APPLICATION NO.	FILING DATE	FIRST NAMED INVENTOR	ATTORNEY DOCKET NO.	CONFIRMATION NO.
09/540,471	03/31/2000	Yuliya Anatolyevna Akulova	1-4-2	2480

Office Action Summary

DETAILED ACTION

FIG 1

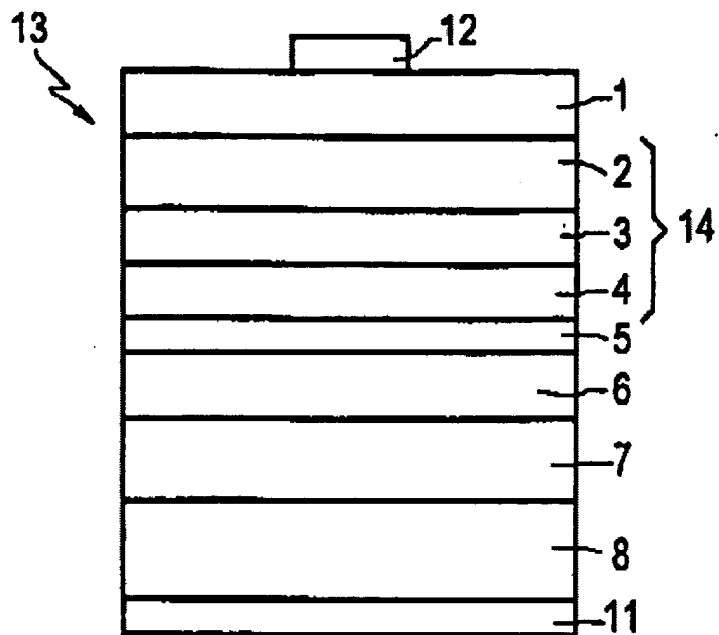
1. The drawing (figs 1-2) is objected for minor informaty. The boxes show in figure 1-2 are not labeled as required by 37 CFR 1.83(a). Applicant is required to submit a drawing correction for approval as require by rule 37 CFR 1.123

With respect to claim 1, Landwehr et al discloses semiconductor laser component comprises a semiconductor body (13), a substrate (8), a first doped InP outer cover layer (7), a first waveguide (6), a MQW (5), a second waveguide (14) includes a first high doped layer (3), a thin barrier layer (10), a second high doped layer (2) and a second outer cover layer (1), note cols 4-6, see figs 1 and 2.

FIG 2

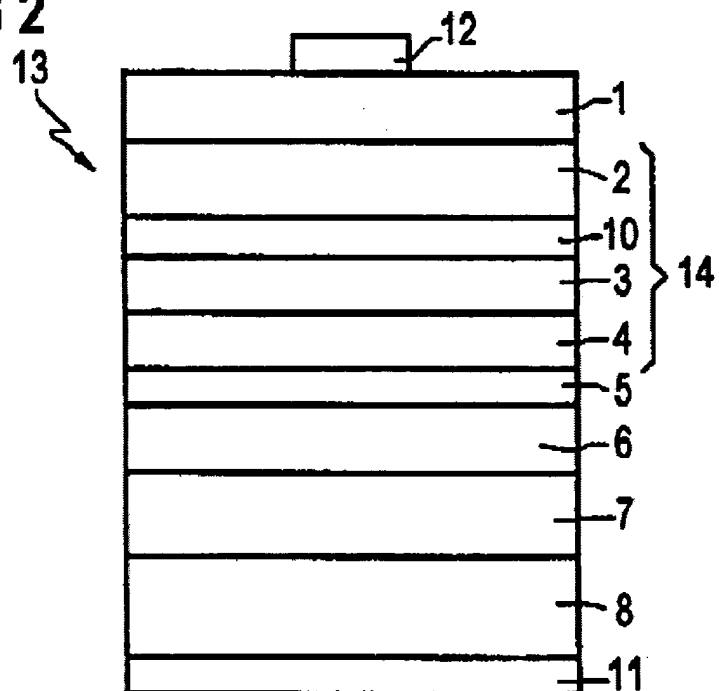
With respect to claim 2, Landwehr et al shows the first and second dopant barrier layers (2, 3), note cols. 4-6 see fig 2.

With respect to claim 3, Landwehr et al discussed about the confinement layer and multi quantum well layer (5), note col. 1, see fig 2.
